Accredited Standards Committee
NCITS, Information Technology

Doc.No. : T13/E01143R1
Date : 12/14/2001
Project : 1410D
Ref. Docs. : T13/E01025R0
Reply to : Mr. Peter McLean
Maxtor Corporation
2190 Miller Drive
Longmont, CO 80501
(303) 678-2149
pete_mclean@maxtor.com

To: T13 Membership
From: Peter McLean, ATA/ATAPI-6 editor
Subj: Response to ATA/ATAPI-6 letter ballot comments

Figure 29 - Host DMA state diagram

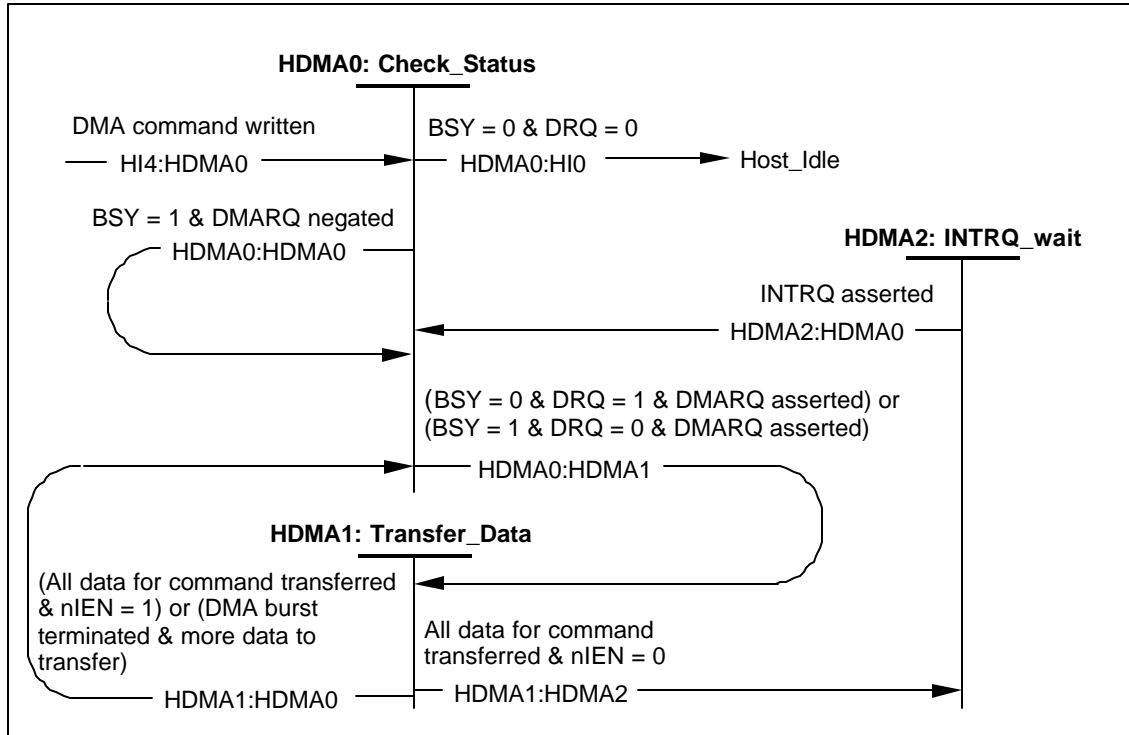
There is confusion as to whether or not all data must be transferred in a single DMARQ/DMACK assertion. To alleviate the confusion, it is proposed that figure 29, the text for the HDMA1 to HDMA0 transition, figure 30, and the text for the DDMA1 to DDMA0 transition be modified as shown.

Transition HDMA1:HDMA0: The host shall make a transition to the HDMA0: Check_Status state when 1) the host has transferred all data for the command and nIEN is set to one, or 2) the DMA burst has been terminated and all data for the command has not been transferred.

Comment accepted

Figure 33 - Host PACKET DMA command state diagram

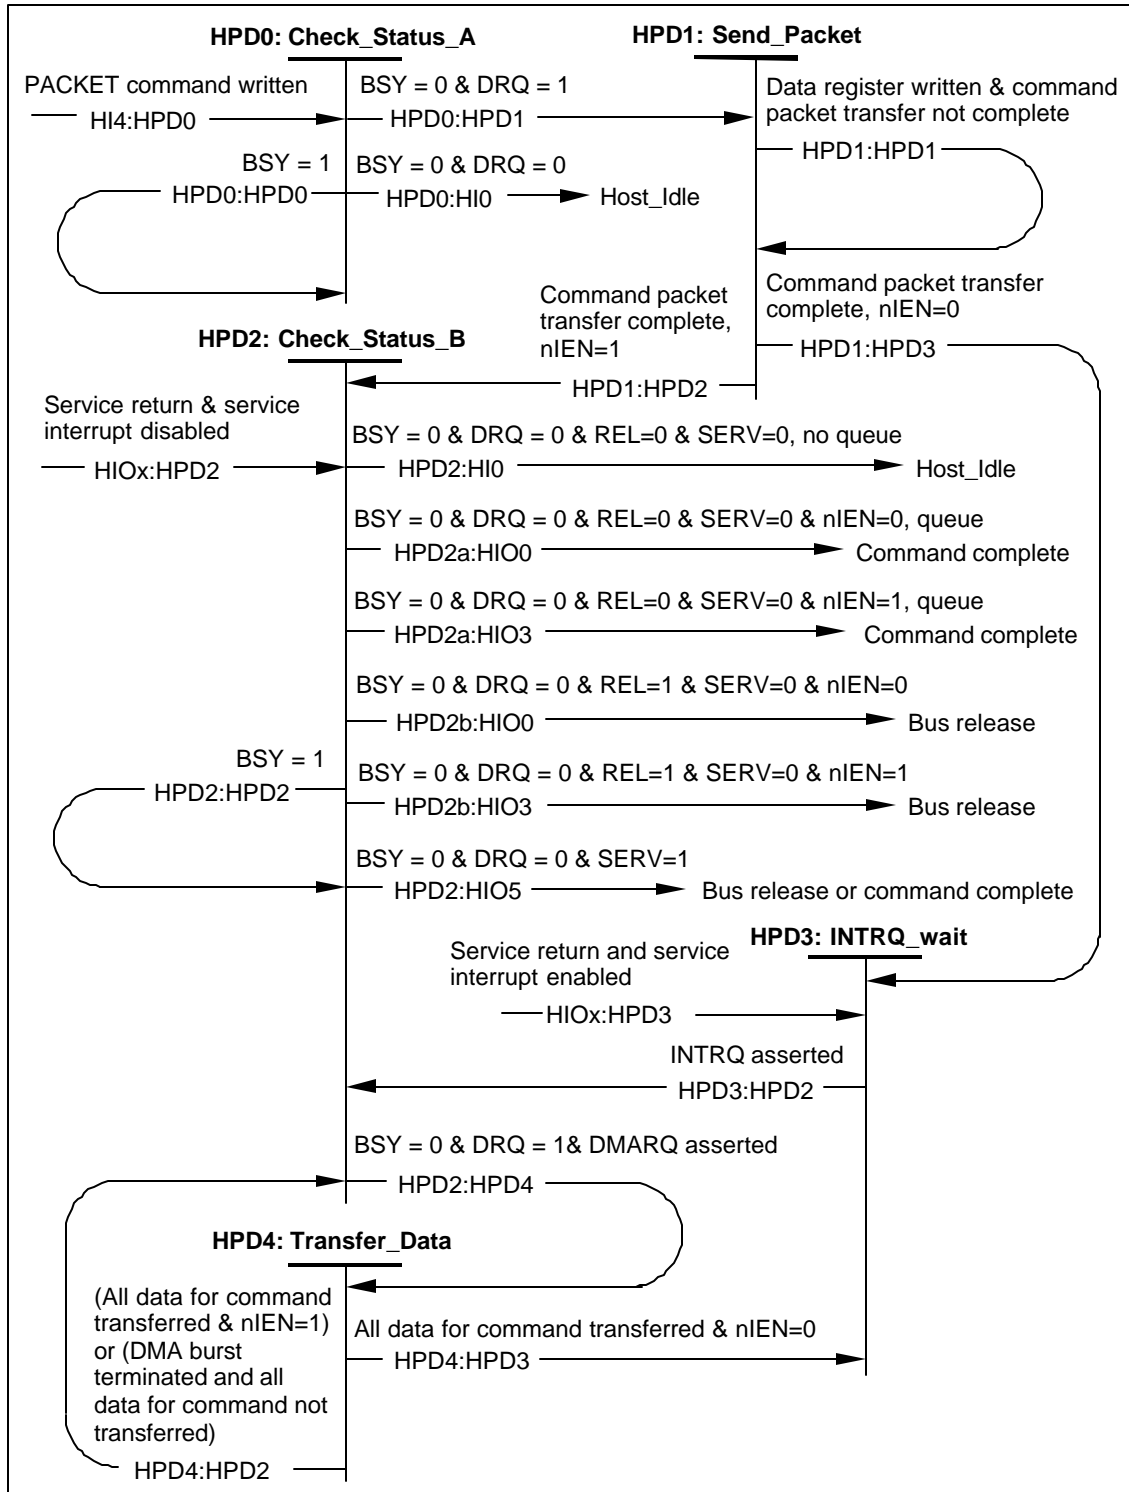
There is confusion as to whether or not all DMA data must be transferred in a single DMARQ/DMACK assertion. To alleviate the confusion, it is proposed that figure 33, the HPD4 to HPD2 transition, figure 34, and the text for the DPD4 to DPD2 transition be modified as shown.

Transition HPD4:HPD2: The host shall make a transition to the HPD2: Check_Status_B state when 1) the host has transferred all data for the command and nIEN is set to one, or 2) the DMA burst has been terminated and all data for the command has not been transferred.

Comment accepted

Figure 35 - Host DMA QUEUED state diagram

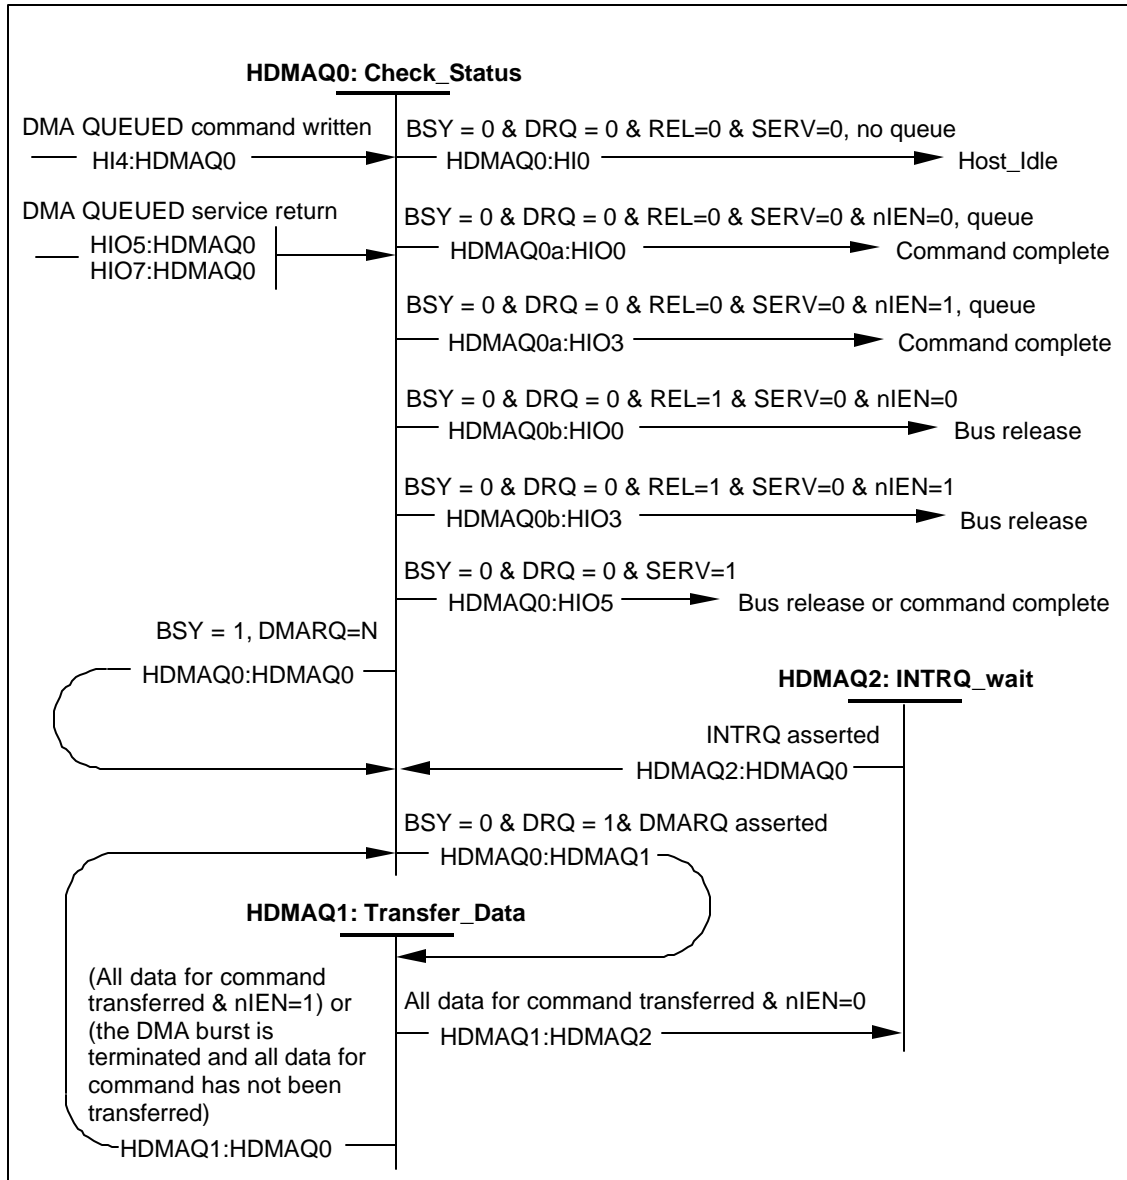
There is confusion as to whether or not all DMA data must be transferred in a single DMARQ/DMACK assertion. To alleviate the confusion, it is proposed that figure 35, the HDMAQ1 to HDMAQ0 transition, figure 36, and the text for the DDMAQ1 to DDMAQ0 transition be modified as shown.

Transition HDMAQ1:HDMAQ0: The host shall make a transition to the HDMAQ0: Check_Status state when 1) all data for the request has been transferred and nIEN is set to one, or 2) the DMA burst is terminated and all data for the request has not been transferred.

Comment accepted
